# Palo Corona Regional Park General Development Plan

Final Initial Study – Mitigated Negative Declaration

**ATTACHMENT 2**

Figure 3 Surrounding Land Uses

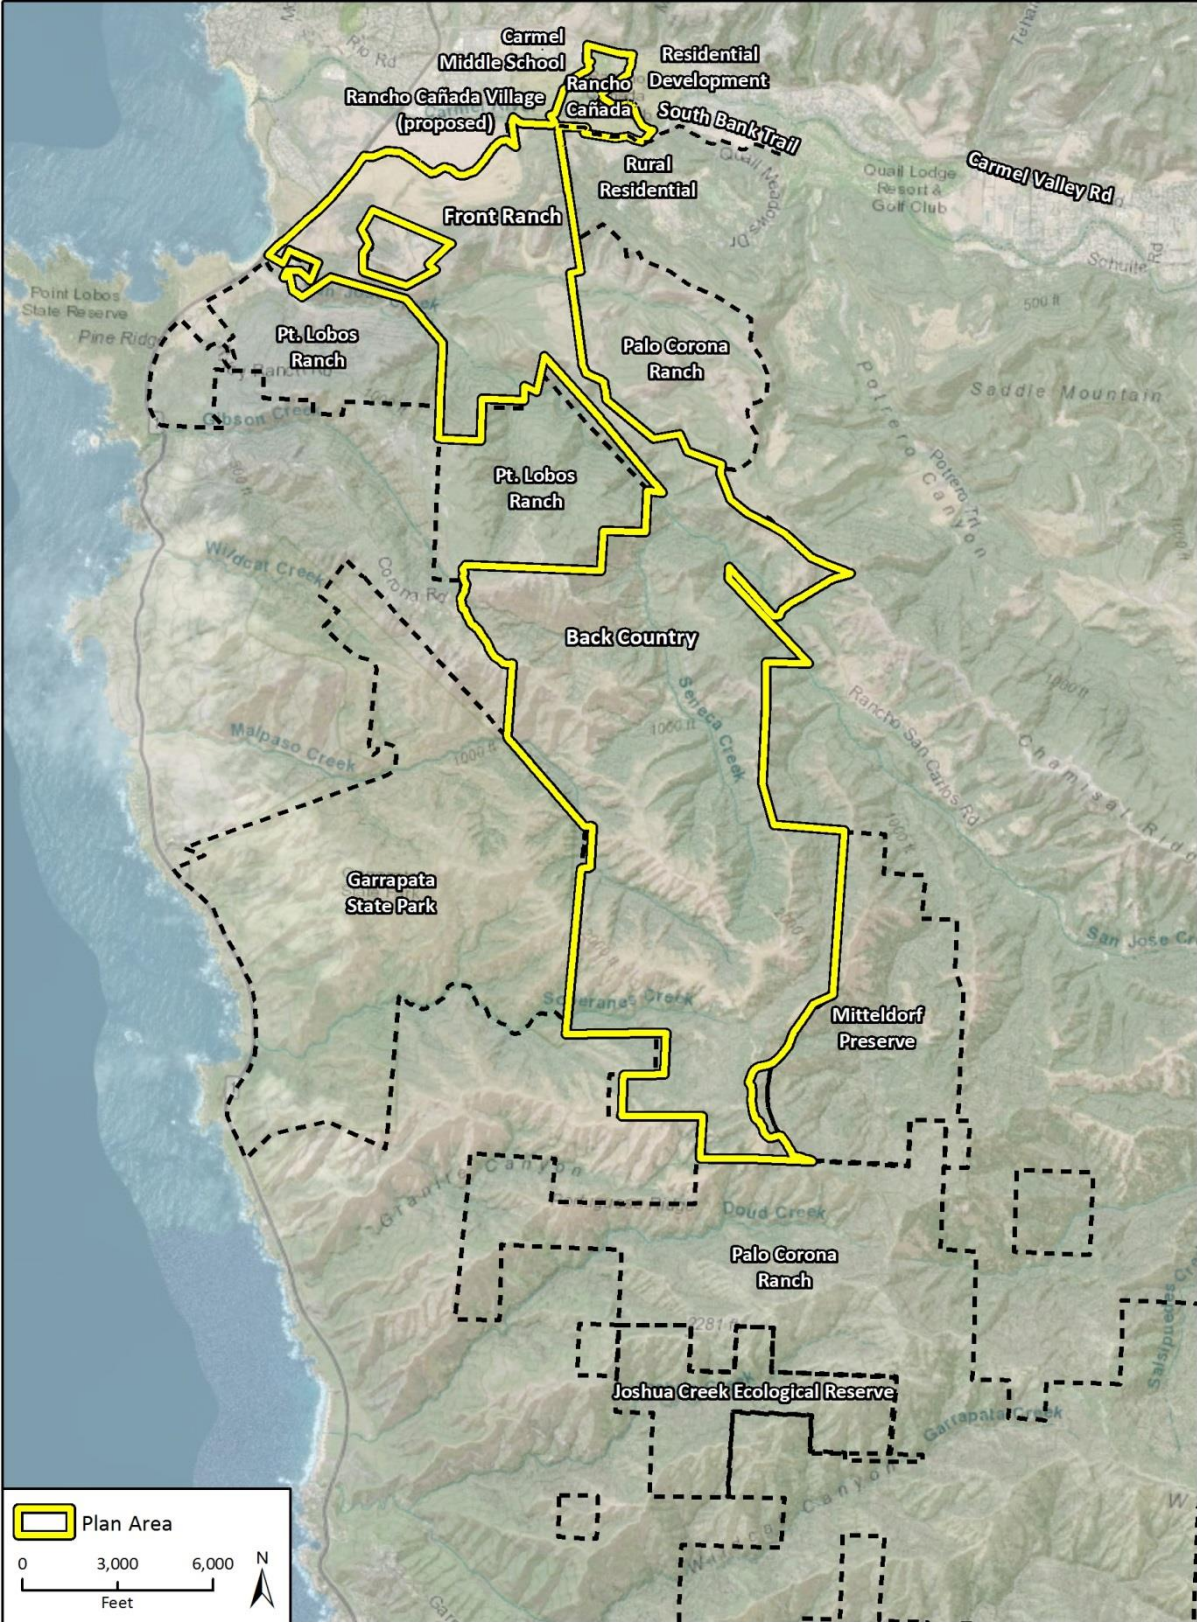
3. Page 4, Last line of Surrounding Land Uses: note typo, "Surrounding land uses are shown in Figure 3." | 6.10

**Figure 5 Front Ranch Unit**

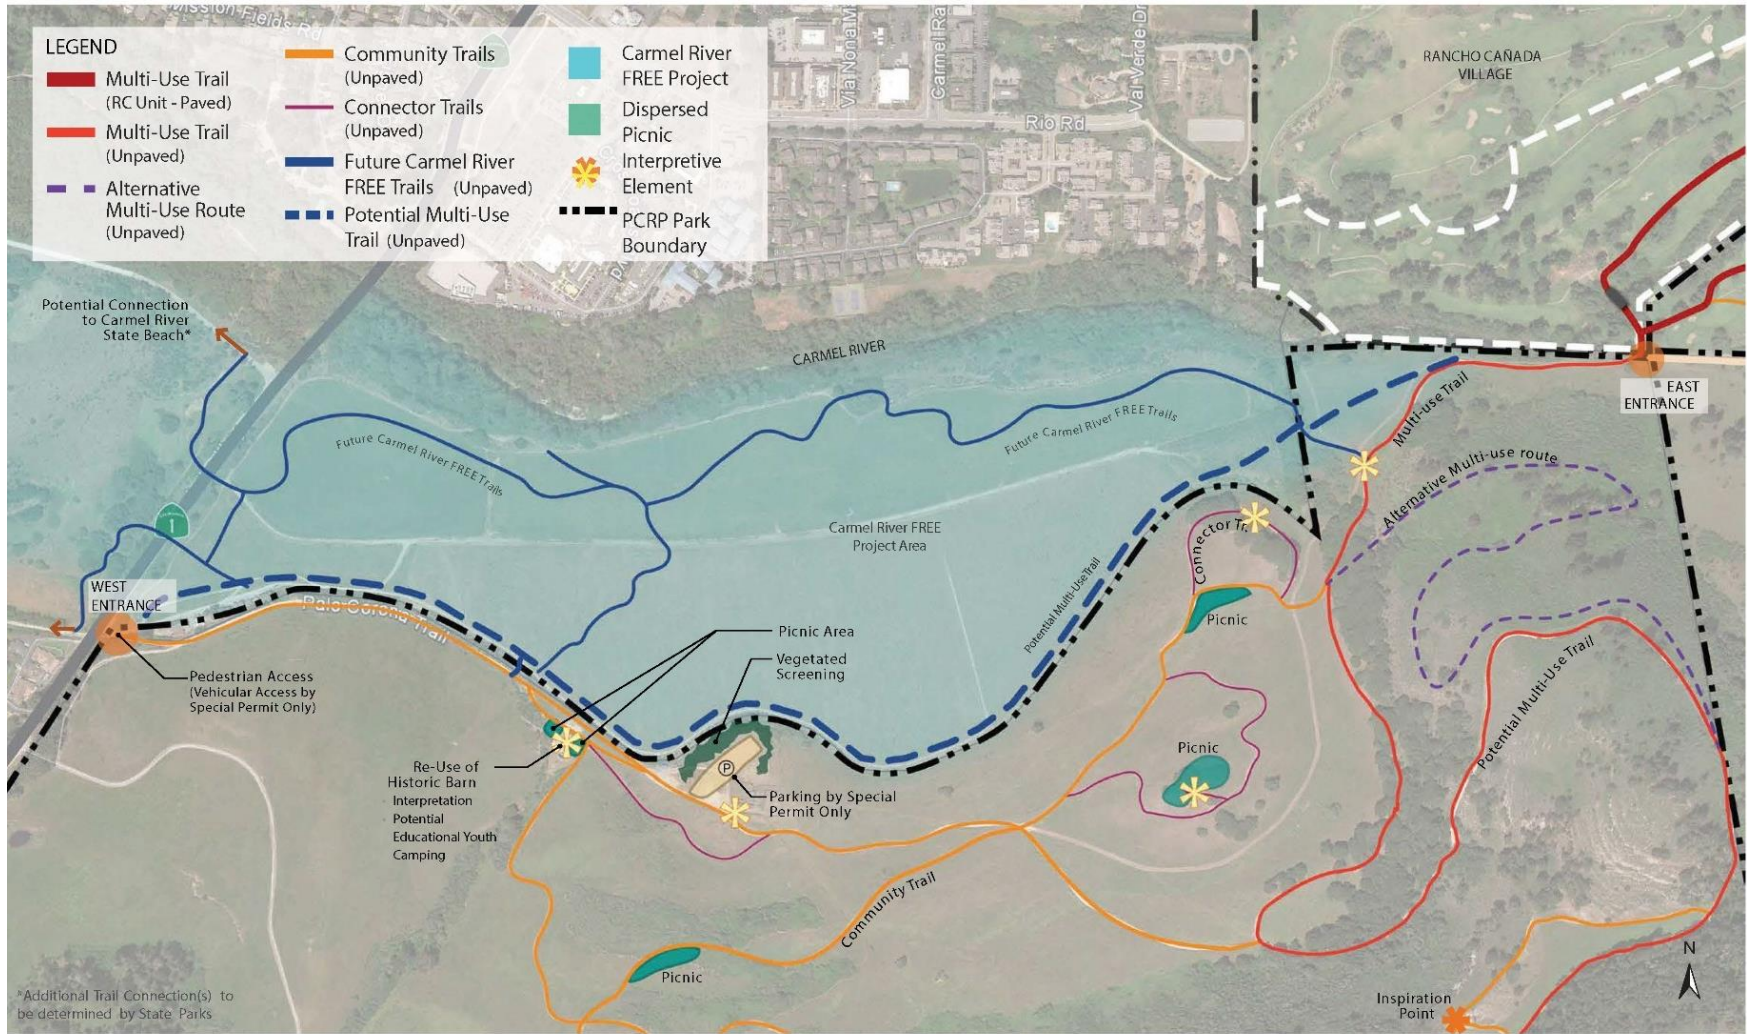
The Park District originally was granted the ability to have 13 visitor vehicles permitted along Highway One. The Initial Study, Figure 5 (p. 11) shows the West Entrance off Highway One, as "Pedestrian Access (Vehicular Access by Special Permit Only)". This practice, and parking vehicles along Highway One, needs to be discontinued with the changes to Highway One as a result of the Carmel River Floodplain Restoration and Enhancement Project. No vehicles should be parked along Highway One at the Park District entrance, permitted or not. As it is, many people use the Park entrance area, as well as Mrs. Fish's driveway entrance, near the Park entrance as a place to make a U-turn and it is not uncommon to see cars parked willy-nilly near the Park entrance, often blocking the fire lane.

Study Figures 5 and 6 (pgs. 11 & 12) show “Educational Youth Camping” and “Youth Educational Camping” as uses, in or near, the historic Barn, all vague references, with no details.

Figure 6 Back Country Unit

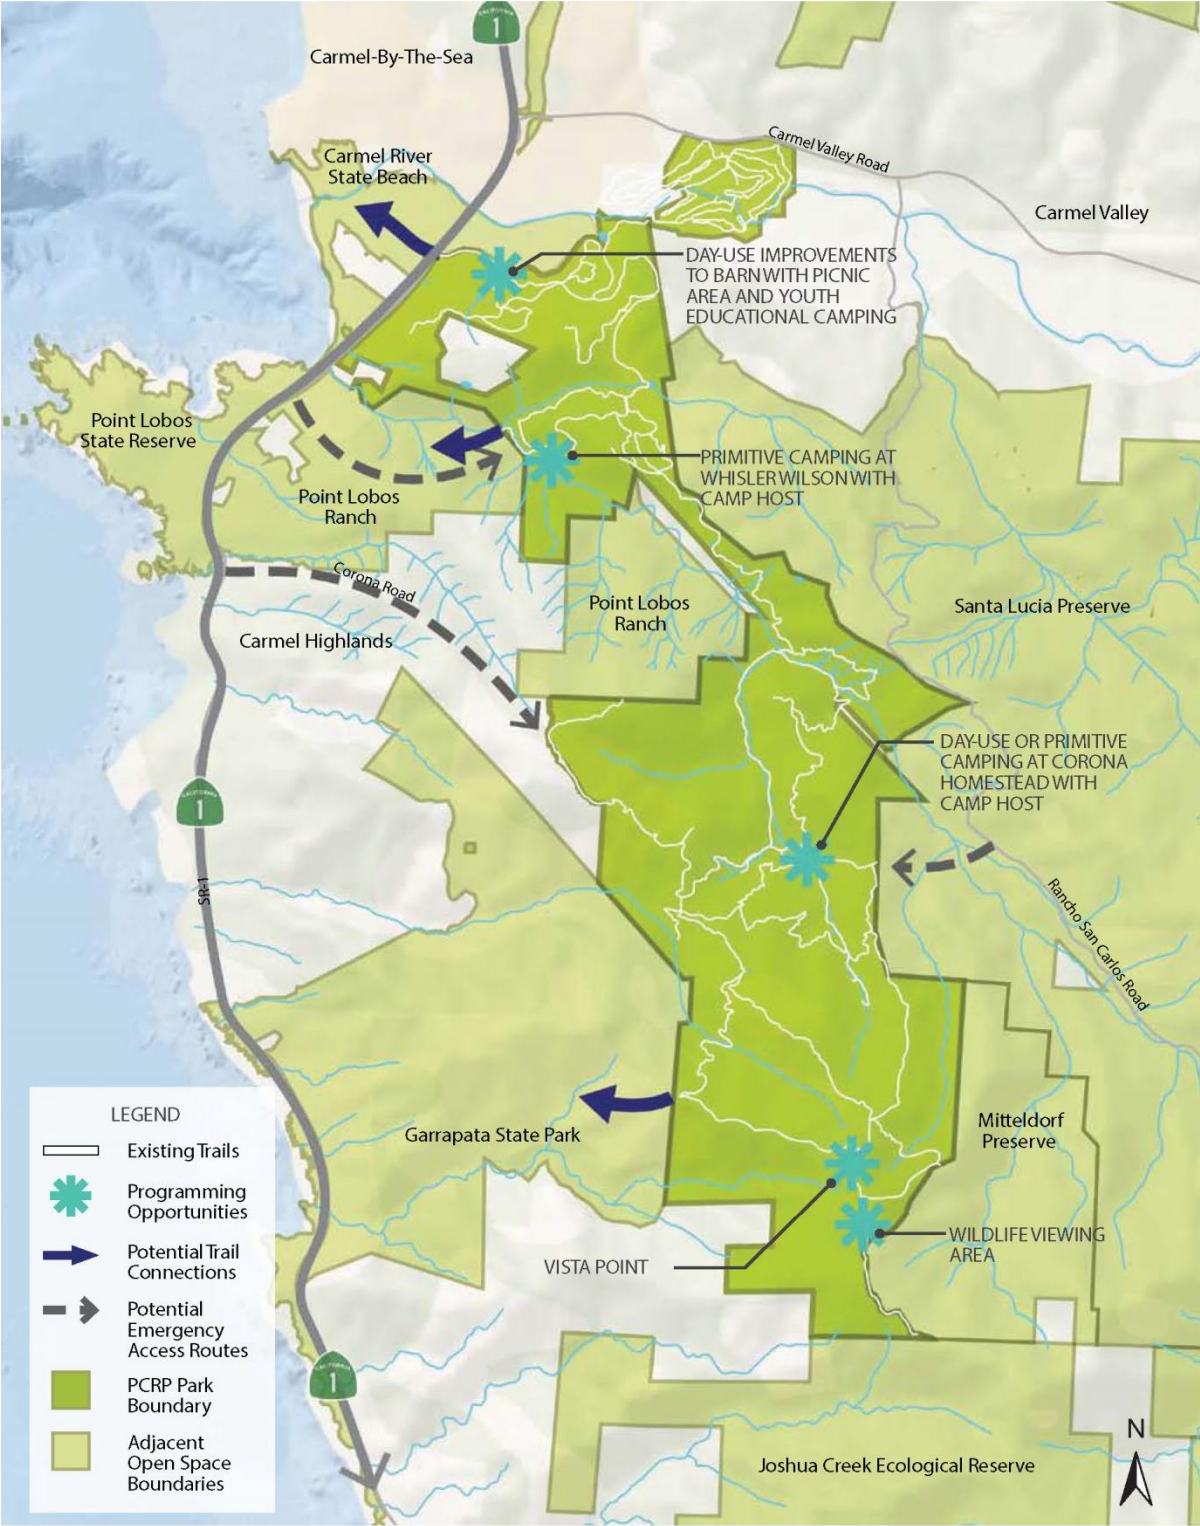
Figure 6 Back Country Unit (p. 12). The map does not identify or discuss the unpaved road that follows the south side of San Jose Creek, which lies partly (SE end) on MPRPD property and partly (NW end) on MPRPD's easement through State Parks property. However, a grey dashed arrow through the middle of Point Lobos Ranch appears to represent this road and is identified as a "potential emergency access route." A solid arrow, "potential trail connection", points towards the area where this road is located. It is my understanding that this road will be the access trail to the Whisler-Wilson property (State Parks is planning to install signs to that effect), and if so, it should be considered within the Area of Potential Effects of this project and should be addressed in this GDP MND/IS.

Figure 6, Back County Unit, of the IS-MND shows existing trails, programming opportunities, and potential emergency access for the Back Country Unit. The figure is not intended to show all existing unpaved roads, only existing trails. As a programmatic document the unpaved road on the south side of San Jose Creek was considered in the overall environmental analysis of the GDP because the road is within the Plan Area depicted in Figure 3 of the IS-MND.
